**Scientific Analysis/Calculation  
Administrative Change Notice**

1. Document Number:	ANL-EBS-MD-000074	2. Revision:	01	3. ACN:	01
4. Title:	Analysis of Dust Deliquescence for FEP Screening				
5. No. of Pages Attached:	5

Figure 6.1-1. Deliquescence of the  $\text{NaCl-KNO}_3\text{-NaNO}_3$  System at Elevated Temperature

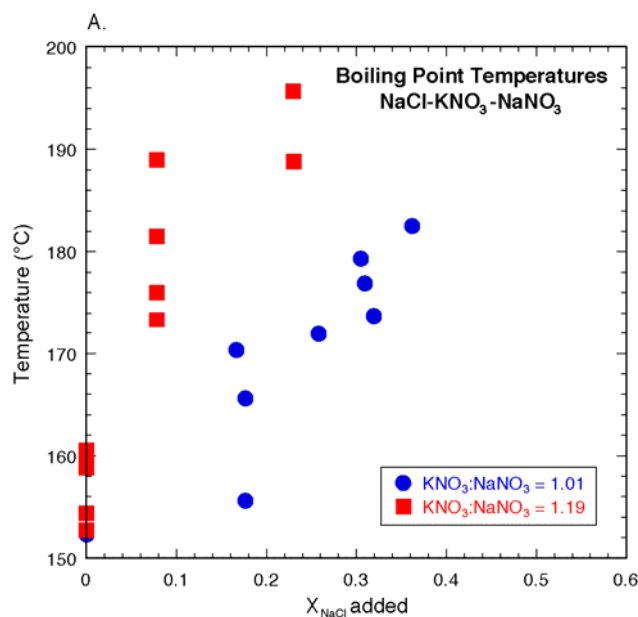
For Section 6.1.2.2, the file *Boiling\_temperatures\_R1c-1.doc* (“Figure 1”) supplies information regarding the dryout temperature of the NaCl–KNO<sub>3</sub> assemblage being below 160°C (DTN: LL040901831032.008 [DIRS 173659]). Also, Figure 6.1-1 uses data boiling point measurement data from this same file (*Boiling\_temperatures\_R1c-1.doc*, “Figure 3”).

NOTES: A. Boiling point measurements at fixed  $\text{KNO}_3:\text{NaNO}_3$  mole ratios versus the mole fraction of  $\text{NaCl}$  salt added; from DTN: LL040901831032.008 [DIRS 173659], *Boiling\_temperatures\_Rlc\_1.doc*, Figure 3.
